APPLICATION No: P21/S3961/CM, (MW.0115/21)

WA/2021/129358/02-L01: EA ref

**Re: Flood risk assessment (FRA) for Extraction And Processing Of Sand And Gravel Including The Construction Of New Site Access Roads, Landscaping And Screening Bunds, Minerals Washing Plant And Other Associated Infrastructure With Restoration To Agriculture And Nature Conservation Areas, Using Inert Fill**

Figure 1: Flow Hydrograph at Reading for baseline and excavation phases SP2 and SP3 for a 1 in 100 year event with 12% climate change.

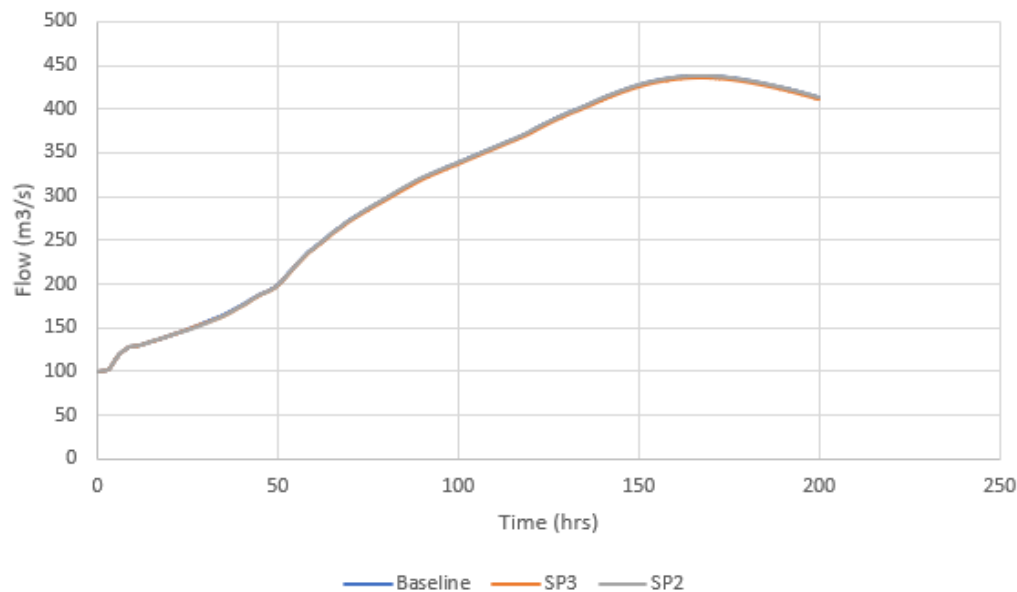
It should also be recognised that the volume of the excavation works is trivial by comparison to the volume conveyed by the Thames during a flood event and the impact downstream (at say Reading) would be *de minimus*. *Figure 1* shows the hydrograph at Reading for a 1 in 100 year event with a 12% allowance for climate change for the baseline and two excavation phasing scenarios (SP3 and SP2).

Figure 2: Magnitude of difference in flows between the baseline scenario and excavation phases SP2 and SP3 for a 1 in 100 year event with 12% climate change.

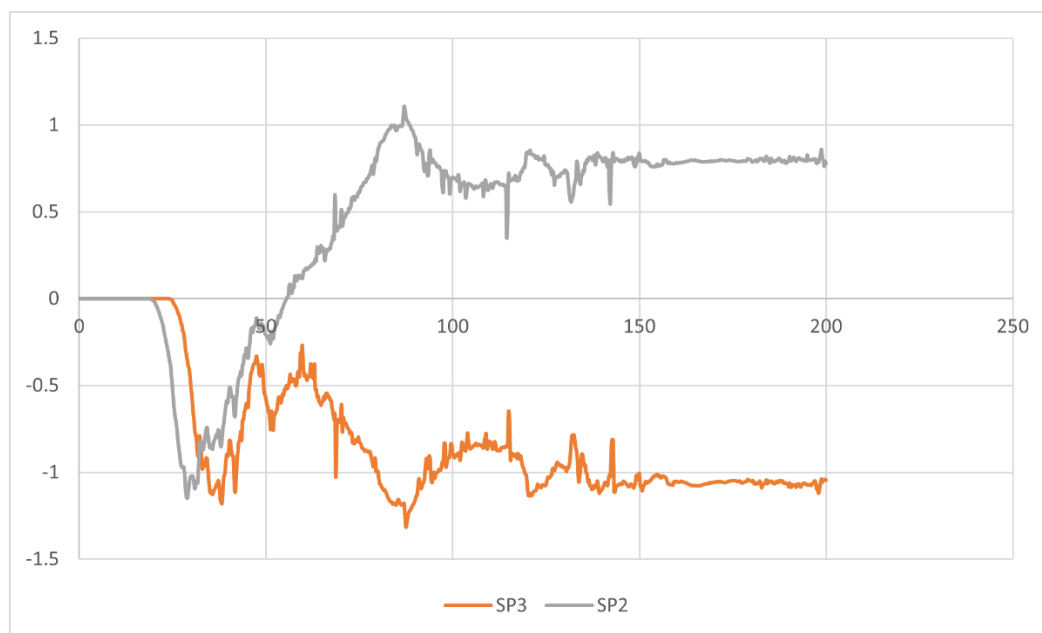
*Figure 2* shows the difference in flow between the baseline scenario and excavation phases SP2 and SP3. The peak of 438 m<sup>3</sup>/s in the baseline scenario compares to 439 m<sup>3</sup>/s (SP2) and 437 m<sup>3</sup>/s (SP3). This represents a difference of approximately 1m<sup>3</sup>/s which is a change of 0.2% on flow which is *de minimus*. The arguments presented above suggests that that should be no increase in flood levels or adverse third-party impacts.

*Figure 3: Cumulative Mass Balance Error for a 1 in 100 year event with 12% cc*

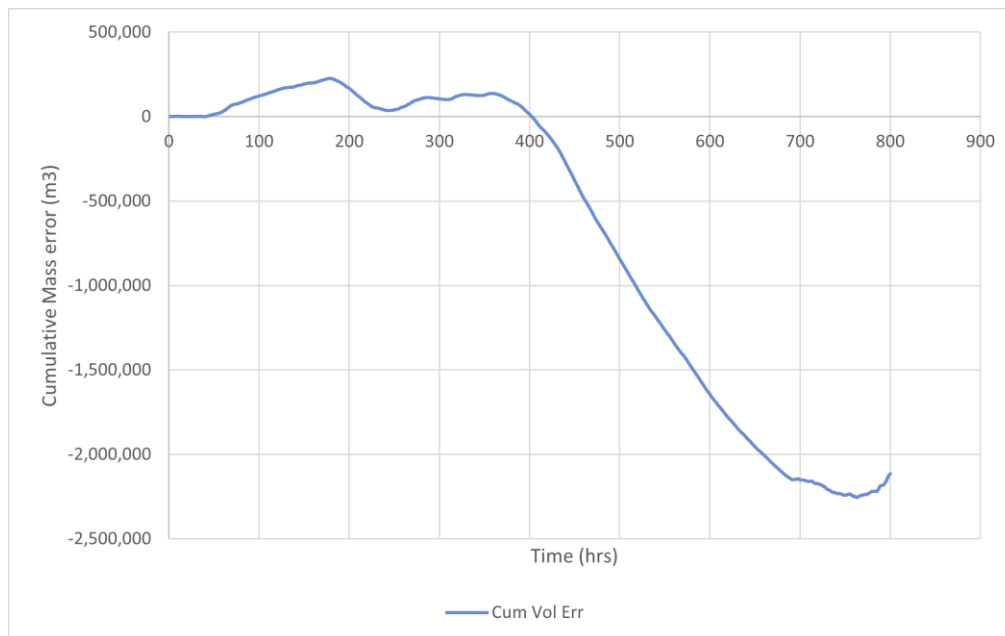
The Edenvale Young review of the Middle Thames model as supplied by the Environment Agency concluded that there were no large, localised instabilities within the model. However, the incoming FMP-TUFLOW model configured with a 12% climate change allowance on flow had a mass balance error of  $-1,652,372\text{m}^3$  at peak water level (See Figure 3 approx. 150hrs simulation time 600 timesteps) for a 1 in 100 year event with a climate change allowance of 12% and a 10m grid using the LiDAR supplied with the model. This is equivalent to an anomalous decrease in water level across the entire model domain of  $-0.048\text{ m}$ .

Accordingly, the limiting accuracy, of the baseline model with the 10m grid is 0.048m. This becomes important when comparing models. The fact that the baseline underreports water levels with a negative mass balance and the Phase 1 excavation model slightly overreports means that the two models are using separate reference levels as shown below.

- The negative mass balance error indicates that the peak levels within the baseline model have been artificially suppressed by an anomalous loss of volume / mass during the simulation. In contrast, the P1 excavation scenario has a positive mass balance error meaning that peak water levels are artificially increased.

- The magnitude of the loss and hence the average accuracy of the baseline model is in the order of -0.048mm across the whole model domain. This implies that the baseline model of the Thames for the 1 in 100 year scenario with 12% climate change using a grid size of 10m is not suitable for assessing flood risk to the degree of accuracy required.

Figure 5: Location of Reference Points

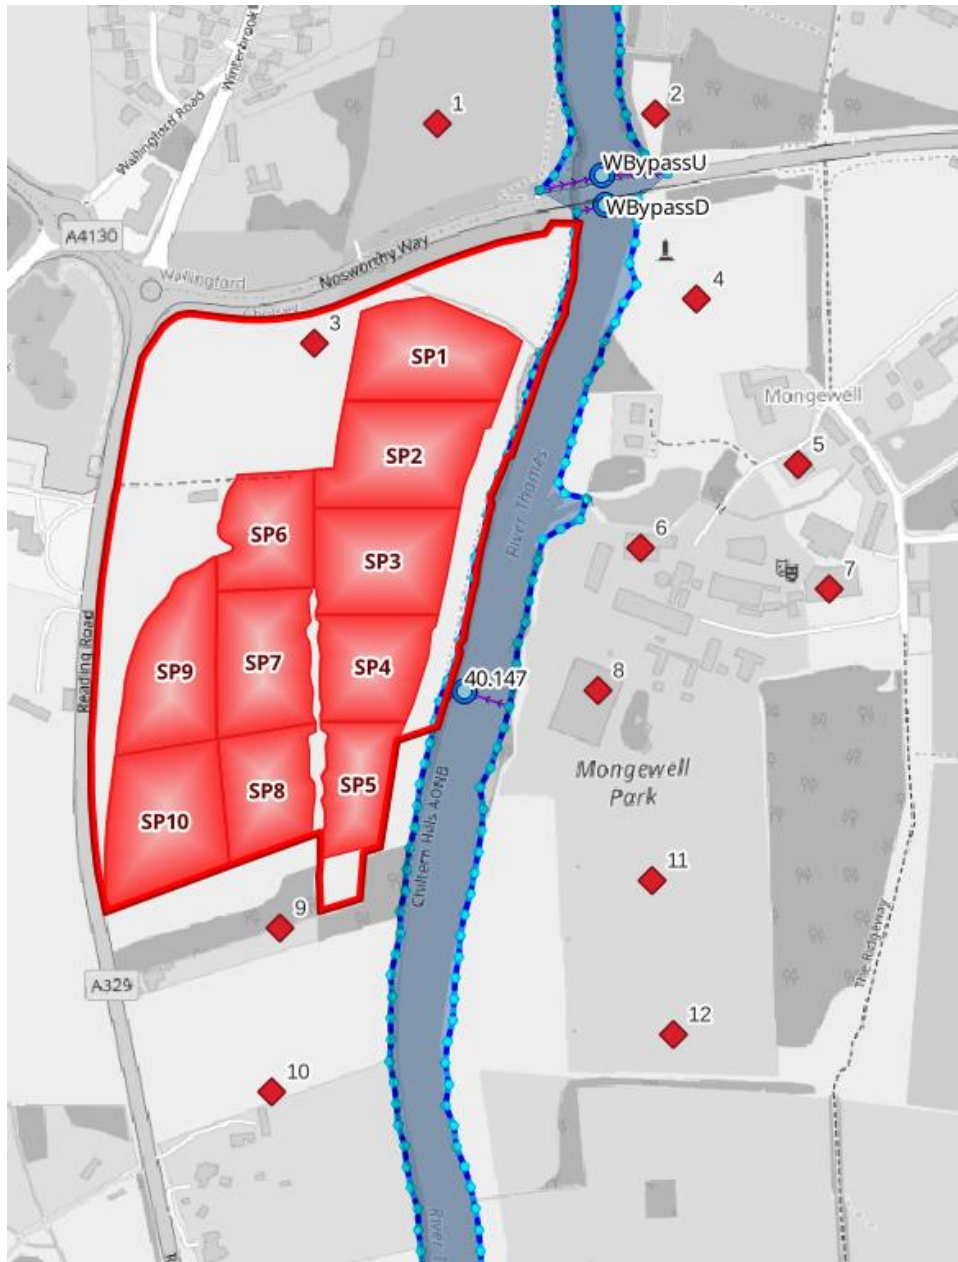
Eleven reference points have been established to determine the impact of the works on water levels (see Figure 5) with the revised configuration of excavation. Table 3 and 4 and Table 4 show the difference between the water level in the Baseline condition and each of the excavation scenarios (SP1 to SP10). Positive numbers show an averaged increase in water level across the whole model and negative numbers show a decrease in water level. Again, it should be stressed that magnitude of the mass balance error will vary along the length of the river.

Figure 7: Water level Difference Mapping for 1 in 100 year event with 12% climate change allowance - Phase SP2 - Baseline

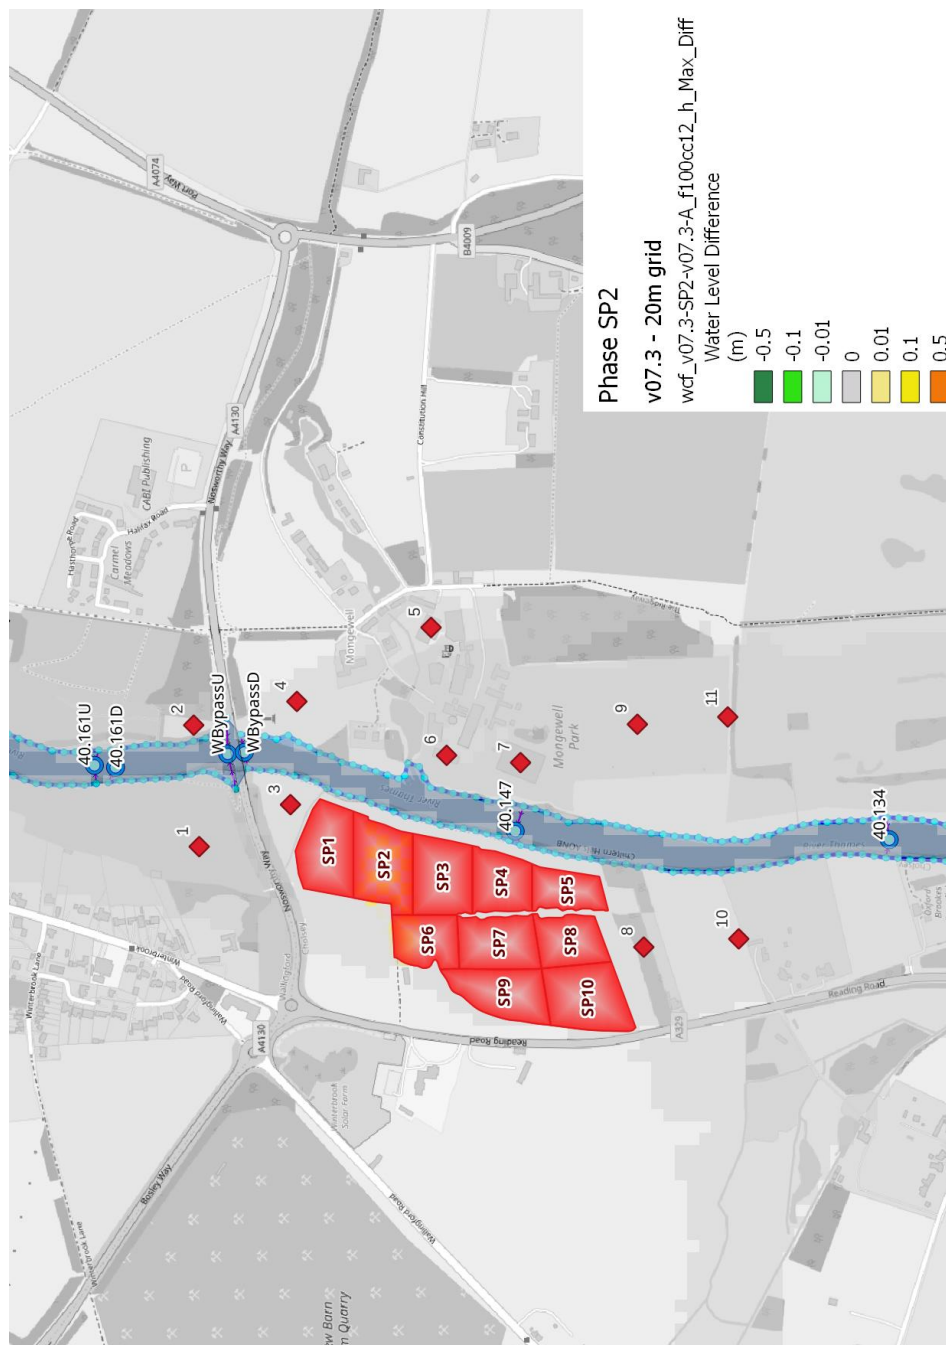
Figures 6 and 7 show the difference mapping for the site with the reconfigured excavation programme. The mapping shows the change in flood levels between the baseline and the excavations scenarios SP1 and SP2. The figures show the numeric difference in baseline and the excavation scenarios. Areas shade grey indicate changes ( $\pm 0.010\text{m}$ ) which are within the joint model tolerance of  $0.024\text{m}$  ( $2 \times 0.012\text{m}$ ) in flood level as a result of the scheme.

Moreover, there are no increases in peak water level greater than 0.006m given in Tables 3 and 4 and all are within the joint model tolerance described above.
